Access Compliance Report

Public Rights-of-Way

(Pedestrian Signals)

Intersection ID: N/A	Main Street:	Cross Street: N/A	Location: N/A
ADA ID: 69BA31D01781	Signal Type: One Push Button-Non APS	Overall Compliance: No	Severity Score: BTN 1: N/A BTN 2: N/A No BTN: N/A
Codes/Mitigation Info/Possible Solution		Field Measurements/Component Compliance

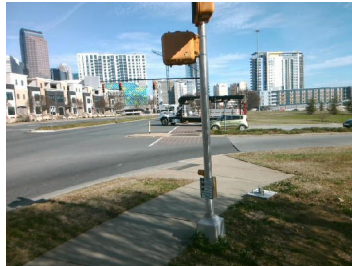
Compliance	Description	Data	Compliance	Description	Data
	Button Count	Button1	N/A	Distant to Additional Button (in)	N/A
	Additional Button Present?	No		Additional Button ID	N/A
N/A	Signal Buttons Required?	N/A	N/A	Additional Ped Posts Required	N/A
	How Many Ped Street Xings?	2		Located In An Island/Median?	No
N/A	B 1 Sign Present?	Yes	N/A	B 2 Sign Present?	N/A
Yes	B 1 Sign Purpose?	Yes	N/A	B 2 Sign Purpose?	N/A
Yes	B 1 Sign Lettering & Contrast?	Yes	N/A	B 2 Sign Lettering & Contrast?	N/A
Yes	B 1 Parallel To XWalk?	Yes	N/A	B 2 Parallel To XWalk?	N/A
Yes	B 1 PAR to Button?	Yes	N/A	B 2 PAR to Button?	N/A
Yes	B 1 PAR to XWalk?	Yes	N/A	B 2 PAR to XWalk?	N/A
Yes	B 1 Clear Floor Space?	Yes	N/A	B 2 Clear Floor Space?	N/A
N/A	B 1 FWD Approach?	Yes	N/A	B 2 FWD Approach?	N/A
N/A	B 1 FWD Approach Constrained?	No	N/A	B 2 FWD Approach Constrained?	N/A
No	B 1 FWD Approach Reach (in)	2.0	N/A	B 2 FWD Approach Reach (in)	N/A

N/A	B 1 FWD Approach Width (in)	N/A	N/A	B 2 FWD Approach Width (in)	N/A
N/A	B 1 FWD Approach Obstruction?	Yes	N/A	B 2 FWD Approach Obstruction?	N/A
N/A	B 1 FWD Approach Obstruction Dist (in)	2.0	N/A	B 2 FWD Approach ObstructionDist (in)	N/A
N/A	B 1 PARA Approach?	Yes	N/A	B 2 PARA Approach?	N/A
N/A	B 1 PARA Approach Constrained?	No	N/A	B 2 PARA Approach Constrained?	N/A
Yes	B 1 PARA Approach Reach (in)	2.0	N/A	B 2 PARA Approach Reach (in)	N/A
N/A	B 1 PARA Approach Width (in)	N/A	N/A	B 2 PARA Approach Width (in)	N/A
N/A	B 1 PARA Approach Obstruction?	Yes	N/A	B 2 PARA Approach Obstruction?	N/A
N/A	B 1 PARA Approach Obstruction Dist (in)	2.0	N/A	B 2 PARA Approach ObstructionDist (in)	N/A
Yes	B 1 Clear Floor Space Slope (%)	1.2	N/A	B 2 Clear Floor Space Slope (%)	N/A
Yes	B 1 Clear Floor Space XSlope (%)	0.1	N/A	B 2 Clear Floor Space XSlope (%)	N/A
N/A	B 1 PAR Slope (%)	0.6	N/A	B 2 PAR Slope (%)	N/A
Yes	B 1 Height (in)	39.0	N/A	B 2 Height (in)	N/A

Yes	B 1 Clear Xing Direction?	ClearlyMarked	N/A	B 2 Clear Xing Direction?	N/A
	B 1 Crossing Direction	To NW		B 2 Crossing Direction	N/A
Yes	B 1 DistanceTo XWalk (in)	0.0	N/A	B 2 DistanceTo XWalk (in)	N/A
No	B 1 DistanceTo Curb (in)	182.0	N/A	B 2 DistanceTo Curb (in)	N/A
Yes	B 1 Diameter (in)	2.0	N/A	B 2 Diameter (in)	N/A

Possible Solutions: Replace Signal Push Button With APS Button on New Post. Remove & Relocate Sign.

PROW/ADA: TMUTCD 4e.08, R406.2
